Project	IEEE 802.16 Broadband Wireless Access Working Group < http://ieee802.org/16 >
Title	Combined figures 498 and 499
Date Submitted	2006-11-12
Source(s)	Peretz Feder - Lucent Technologies [mailto: pfeder@lucent.com]
Re:	
Abstract	Combined Figures 498 and 499
Purpose	Adoption
Notice	This document has been prepared to assist IEEE 802.16. It is offered as a basis for discussion and is not binding on the contributing individual(s) or organization(s). The material in this document is subject to change in form and content after further study. The contributor(s) reserve(s) the right to add, amend or withdraw material contained herein.
Release	The contributor grants a free, irrevocable license to the IEEE to incorporate material contained in this contribution, and any modifications thereof, in the creation of an IEEE Standards publication; to copyright in the IEEE's name any IEEE Standards publication even though it may include portions of this contribution; and at the IEEE's sole discretion to permit others to reproduce in whole or in part the resulting IEEE Standards publication. The contributor also acknowledges and accepts that this contribution may be made public by IEEE 802.16.

Figure 498 – Ranging Primitives (MS and BS)

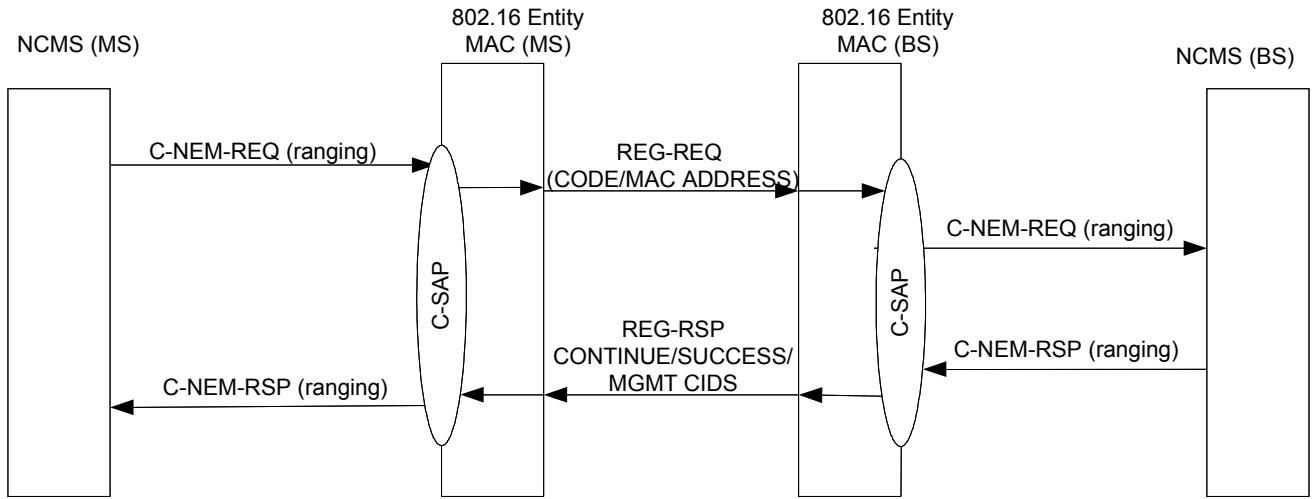
Ranging Primitivesm, present end-to-end view of Figures 498 and 499

Reproduce in a format that shows end-to-end exchange of RNG-REQ and RNG-RSP between MS+NCMS and BS+NCMS

In section 14.2.8, combine Figures 499 and 498 per below:
